Commonwealth Edison
Braidwood Nuclear Power Station
Route #1, Box 84
Braceville, Illinois 60407
Telephone 815/458-2801

Subject: Teleconference between Commonwealth Edison Company and the
Nuclear Regulatory Commission dated October 3 and 4, 1995,
Regarding the Increase in the Interim Plugging Criteria for Byron
Unit 1 and Braidwood Unit 1
NRC Docket Numbers: 50-454 and 50-456

**MODEL D4
TOP PLATE**

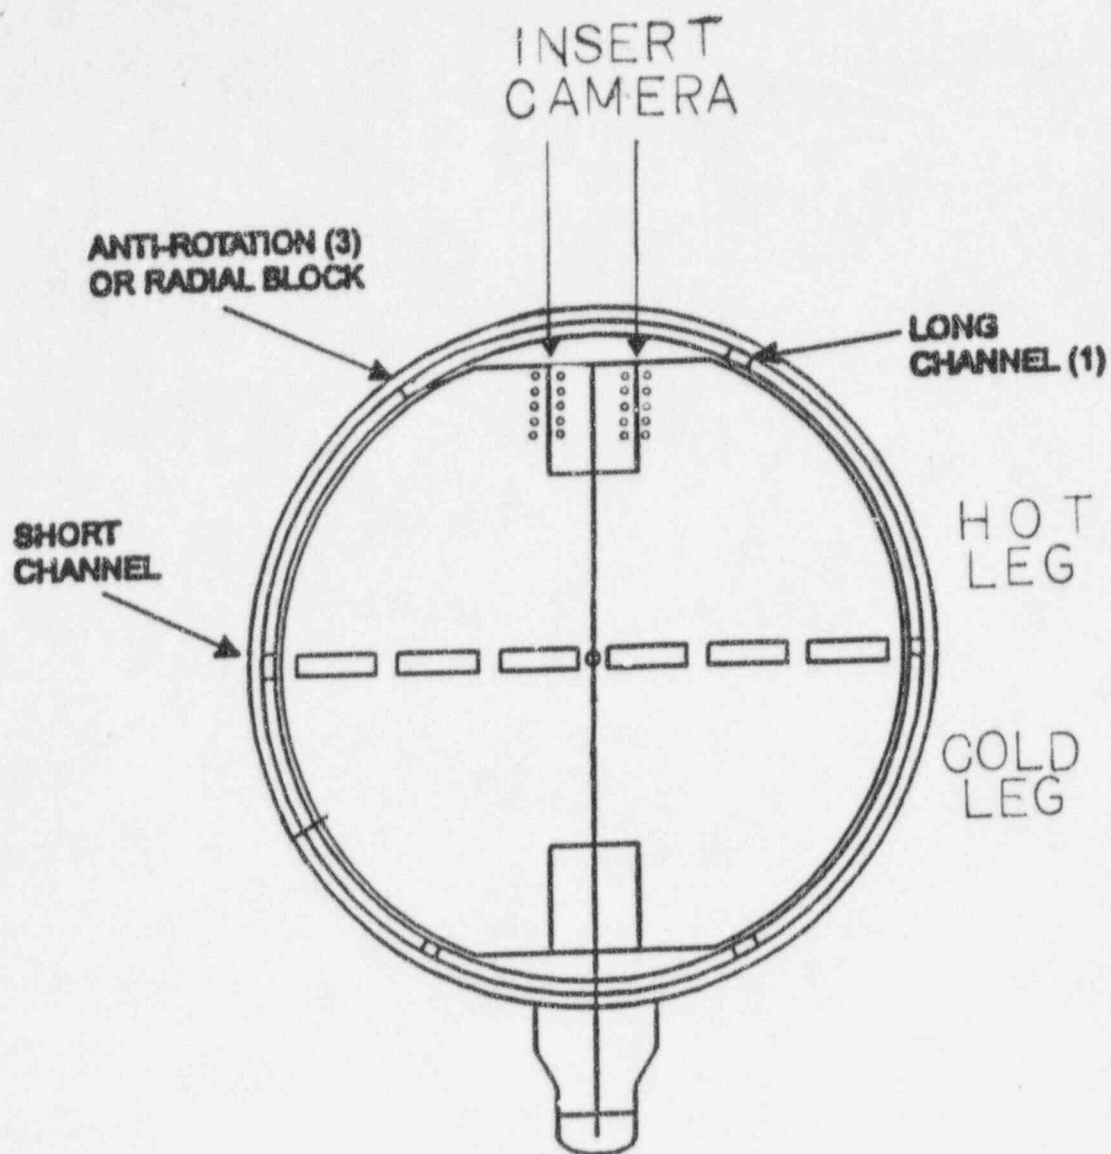
During the Braidwood Unit 1 refueling outage a visual inspection of the "A" SG top TSP patch plate area will be performed. The inspection will consist of inserting a camera along the 2 accessible patch plate seams to a distance of 5 tube rows (see attached sketch). This visual inspection is intended to determine if TSP degradation is present in this area. Those TSP intersections that have received visual inspection (20 tubes), will also be eddy current inspected and data analyzed using techniques and analysis guidelines developed through the EPRI program to detect TSP degradation. The eddy current responses seen in the SG will be compared to those obtained in the EPRI mockup and any ambiguous signals will be investigated and reported to the Staff.
